2005 5TH AVE

DESIGN REVIEW BOARD RECOMMENDATION MEETING PROJECT NUMBER: 3028017 MEETING DATE: 02/21/2023

**EDG 3 DESIGN**

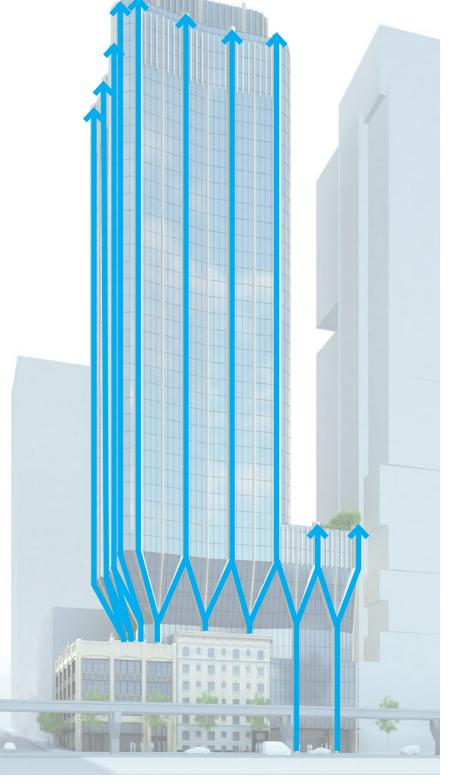
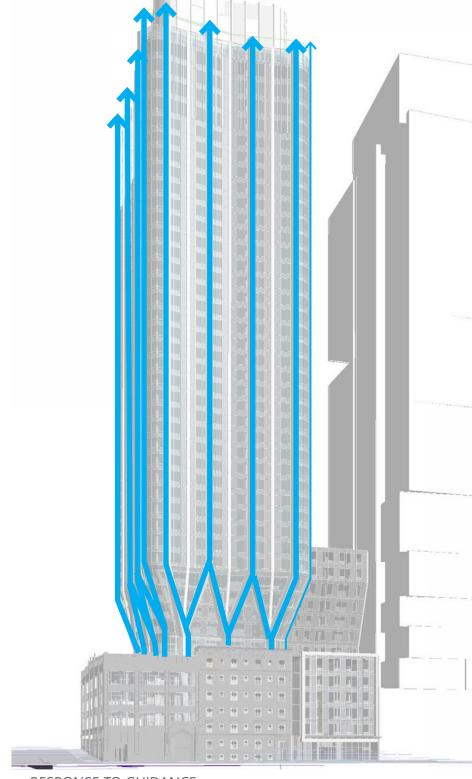
ITEM	BOARD GUIDANCE Jan 04, 2022	RESPONSE
1. Podium to Tower Transition	<ul> <li>1.a The Board acknowledged the complex project conditions and that it resulted in the proposed tower location.</li> <li>1.b The Board supported the design to carry elements of the tower language down to the new podium piece. In addition, the Board supported the updated proposed podium height, study of the podium notch and proposed location, and shifting the lobby to better align with the new podium area.</li> </ul>	1. The response to guidance incorporates a revised upper podium element that is set back from the tower form on both the east and west sides. All 4 corners of the tower are now clearly delineated, creating a symmetrical tapered form that is true to the tower's New Formalism design style. Additionally, the new podium piece becomes a liaison between the two towers for a subtle transition and a strong base to support the towers proportionally.

The response to guidance incorporates a revised upper podium element that is set back from the tower form on both the east and west sides. All 4 corners of the tower are now clearly delineated, creating a symmetrical tapered form that is true to the tower's New Formalism design style. Additionally, the new podium piece becomes a liaison between the two towers for a subtle transition and a strong base to support the towers proportionally.

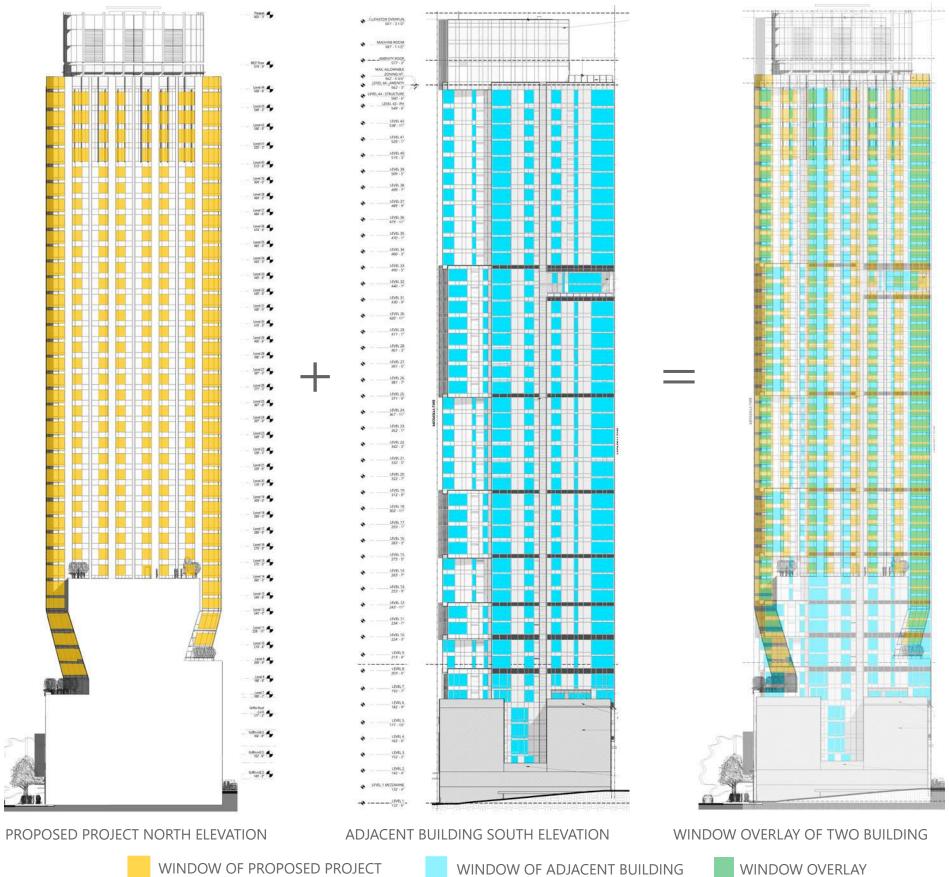
The Board would like to see window overlay privacy studies, demonstrating how proposed windows will be located in comparison to residential buildings adjacent to the site

The study illustrates the relationship between the north façade of 2005 5th Avenue and the south façade of the 5th and Lenora project. The facades are separated by 60' in the north-south direction and there is about 5' difference between the floor levels of the two projects. This staggering of the floor-tofloor relationships, in addition to the indented façade and rounded corners of the 2005 5th Avenue tower proposal serves to mitigate the issue of direct visual access between the two towers.

### **ALLEY SIDE**

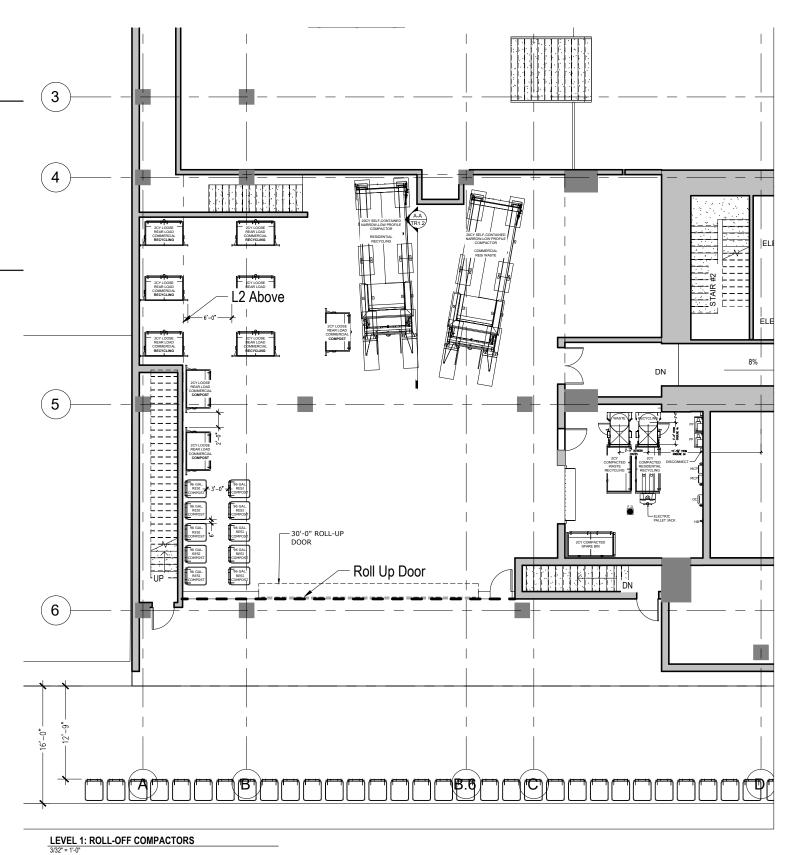
The Board required additional information from SDCI, SDOT and SPU.
